STATE OF COLORADO

DIVISION OF RECLAMATION, MINING AND SAFETY

Re: Schwartzwalder Mine, Jefferson County, Permit No. M-1977-300, Designated Mining Operation Environmental Protection Plan, TR-11, Adequacy Review #2

Dissolved Uranium Result for Samples @ Long Lake Head Gate

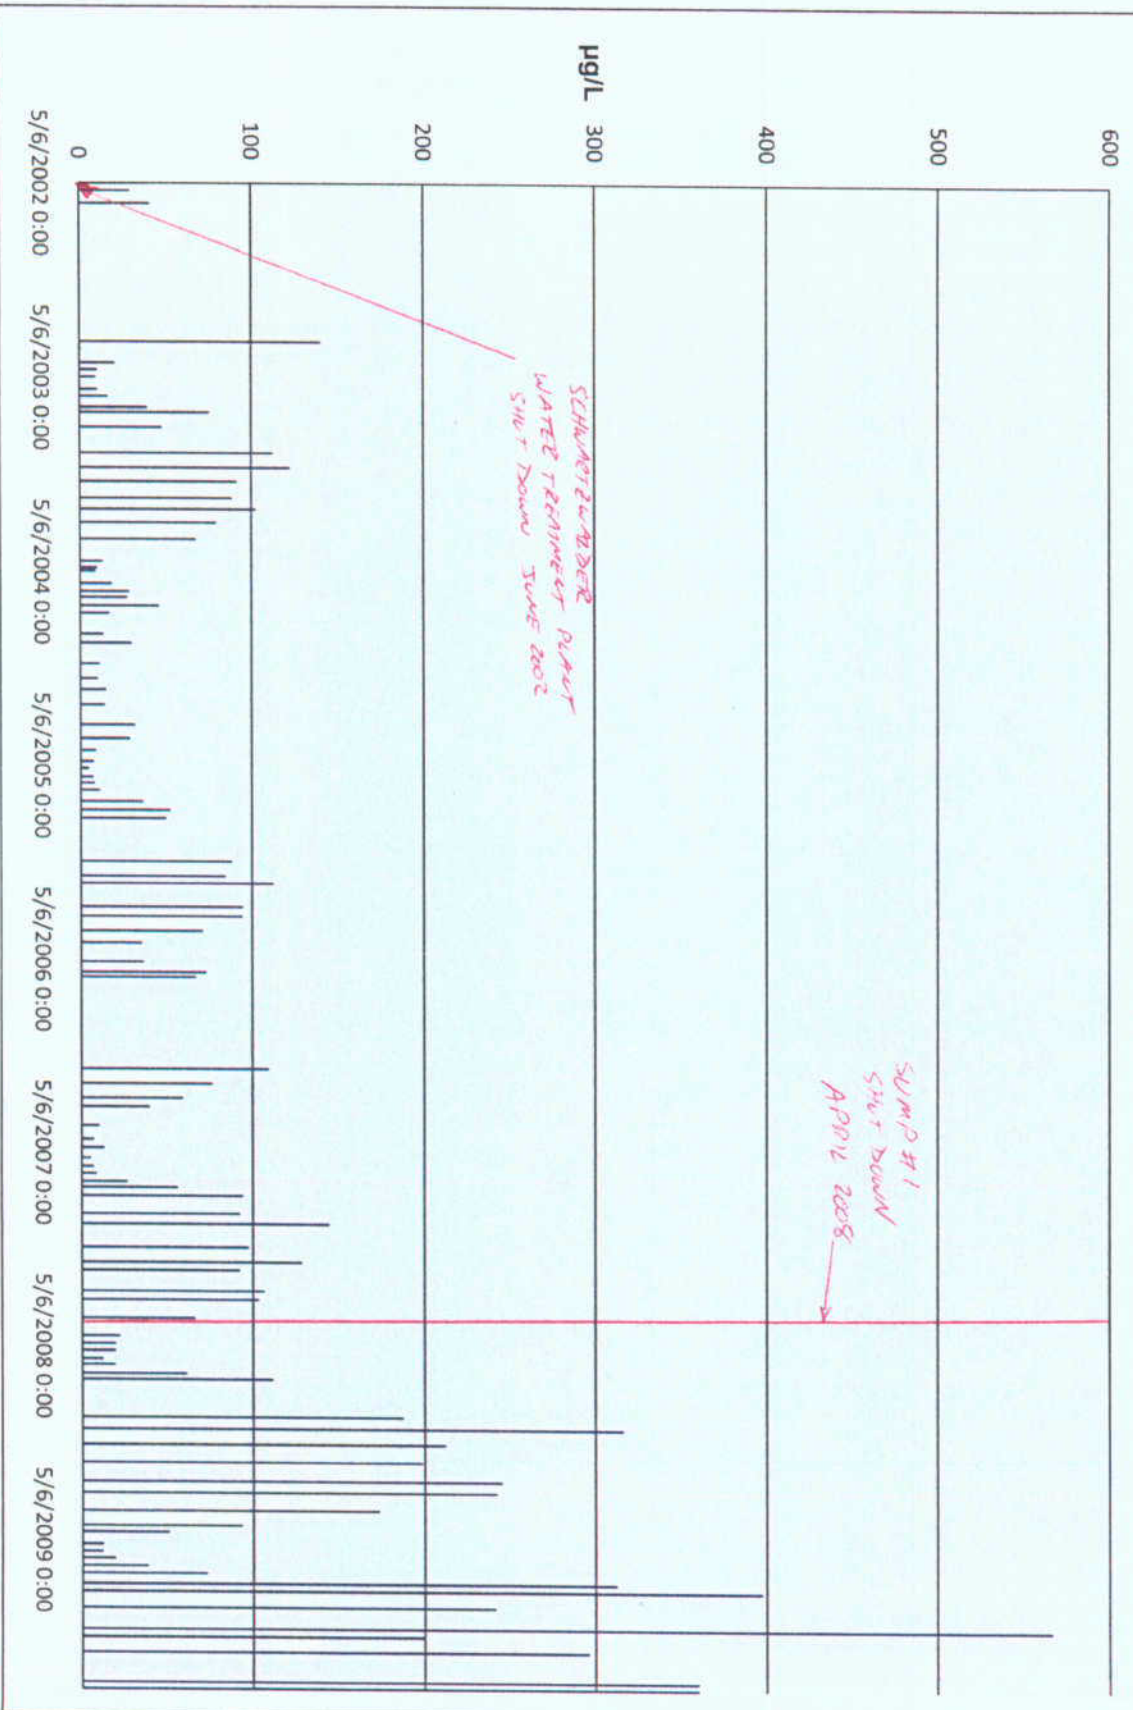
Denver Water data shows that uranium concentrations in Ralston Creek (at the Long Lake Headgate) were fairly stable, though still above the drinking water limit, at 80-100 µg/L until October 2008. This date seems to correspond to the general timeframe when Sump 1 was turned off at the Schwartzwalder Mine and the water level in the mine reached “steady state.” Since October 2008, uranium concentrations in Ralston Creek entering Ralston Reservoir have risen steadily to over 500 µg/L.
